**CITY OF OLYMPIA HEARING EXAMINER  
STAFF REPORT  
May 1, 2026**

**Project Name/File No.:** West Bay Yards, 21-2854

**Requested Action:** Shoreline Substantial Development Permit and Shoreline Conditional Use Permit: Applicant proposes a Shoreline Substantial Development Permit to construct five buildings above a public plaza and structured parking. Each of the five buildings will include five stories. The project includes 478 residential units, approximately 22,000 square feet (SF) of commercial use such as restaurant/café, an expanded waterfront trail and various public amenities.

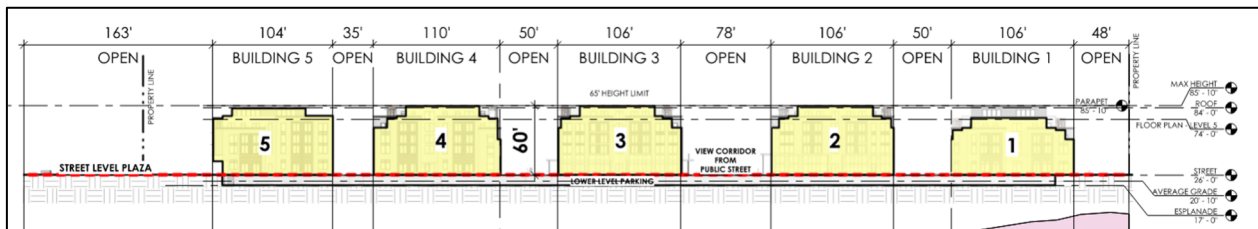
b. All projects adjacent to this trail corridor are required to install their portion of the trail. As seen in the snip of the trail map, the trail wraps around this site, extending not only along the shoreline but connecting back to West Bay Drive on the North and South of the site. It is defined as a Regional Commuter Trail. The Engineering Design and Development Standards (EDDS) provide the required dimensional standards for a Commuter Multi-Use Trail. The trail is required to provide no less than 12’ of pavement with 2’ of shoulder. Typically, additional area is required for ease of maintenance which expands the total corridor to 22’. In this case, the easement width can be reduced because maintenance will be borne by the property owner rather than City. In order to meet the standards for a Waterfront Trail, the publicly usable space of the trail cannot be reduced below 12’, which is shown on plans.

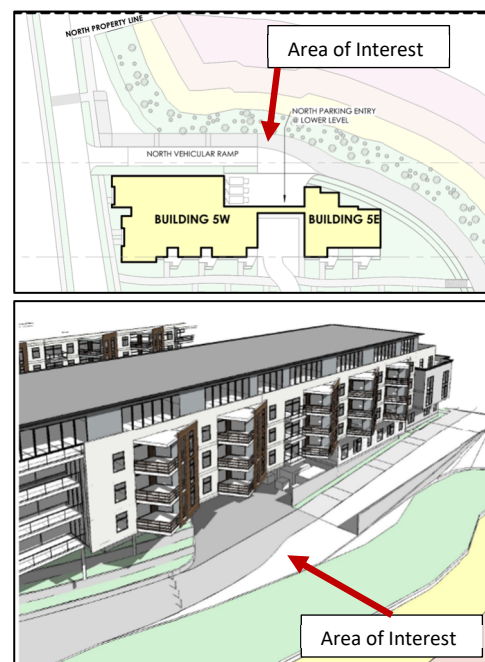
*An area of interest is the intersection on the North trail where it connects to the expanded waterfront trail corridor. In this location there are several uses that occupy the same location. The vehicular exit location of the parking garage, the solid waste compactors, the pedestrian/bike trail, and the fire truck access point all use this same location, which makes it a high use area. SPRC has been particularly focused on this location to ensure it is designed to function for all relevant components and is safe for pedestrians and cyclists. Conceptual project plans for each component are available, but there is not one image that shows how they all overlap in detail. The snip above is from A 10 of the Architectural plan set (Attachment 2), called “Building Phasing Plan.” This location will be addressed in other sections of this report. Conditions of approval have been added to ensure construction plans provide the necessary features for safety and compatibility of the various uses.*

**Vegetation Conservation Areas, OMC 18.20.490 -18.20.496:**

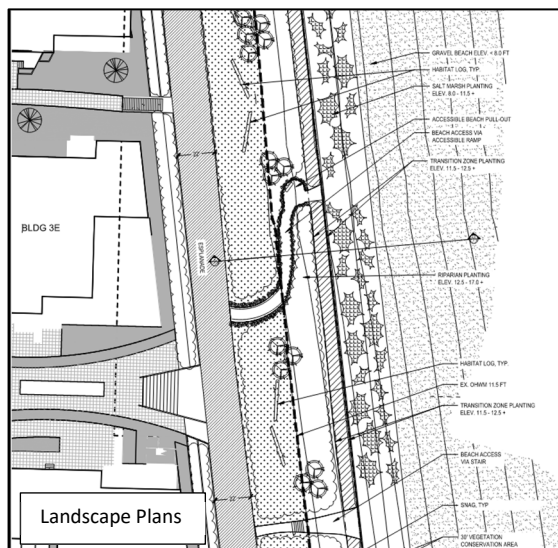
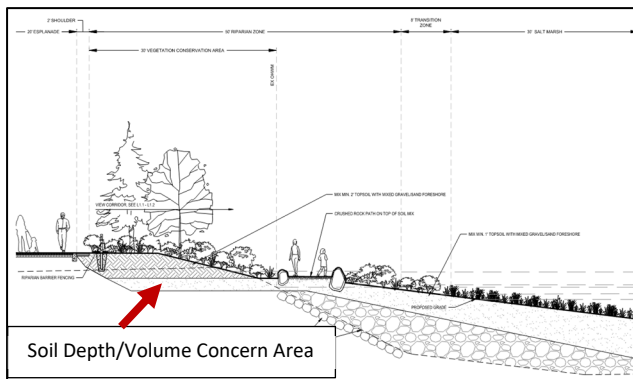
The existing VCA is devoid of native planting and will need to be replanted in its entirety. The conceptual planting plans indicate the area will be planted with a dense native vegetation, however the plans do not indicate how much of the existing soil is suitable for planting. Existing site conditions such as the unknown makeup of the fill, soil contamination, location of riprap seawall, and the potential for saltwater intrusion combine to indicate more information about the amount of soil volume available for planting large native trees and other native vegetation in this area is needed. Plans indicate a minimum of two feet of imported soil will be provided across the entire site, but it is unclear if this soil is intended to be hardened through ground improvements and therefore unable to be planted on or if this area is intended to be amended with nutrient rich and deep soil that will allow for native vegetation. Soil depth, irrigation, and total soil volume remain at issue. Further, the MTCA clean-up approach identified in plans indicates a “cap” is likely which would need to be specifically designed to allow for adequate soil depth for a dense forested condition similar to what is found across the bay at Squaxin Park. It is likely that contamination removal under the VCA is necessary to achieve adequate soil depth for soil volumes necessary to accommodate large tree species. This will need to be included in the MTCA cleanup plan design. The project should be conditioned to ensure engineering plans provide adequate details for how the VCA will achieve a dense native plant community including large trees. Updates are warranted in the mitigation, restoration, and landscaping plans submitted with the engineering permit. Should the MTCA Clean-up preferred alternative result in a limited area for planting, the project will likely need to be redesigned to ensure code compliance. This could result in a larger buffer and modifications to the upland development size, shape, or location.

The OHWM is being relocated waterward by 12' to 18'. This will essentially expand the 30' VCA to 42' to 48' VCA once the project is complete. Plans will need to clearly demonstrate the location and width of the VCA as well as which areas are to be considered the SVPA within the VCA. Notices to title will be required to ensure these areas are required to remain in a native vegetated state in perpetuity.

Engineering permit plans will need to more clearly identify where amenities such as picnic tables, benches, and other public amenities are proposed as they will not be permitted within the Expanded Waterfront Trail Corridor. Images from the preliminary landscaping plans (Attachment 5) show the VCA and trails. A few intrusions into the VCA are proposed including the three 6' wide pathways to the shoreline edge, and the Waterfront Trail location on the northern portion of the property (identified as an area of interest). Here there are several competing uses and the trail needs to push into the VCA to ensure pedestrian safety. These intrusions are permitted in code and are compensated by the increased width of the VCA as well as a few other areas being used to compensate the loss of VCA area. Condition of approval will be added to ensure the additional 12' to 18' in VCA width is titled as such on supplemental project plans.
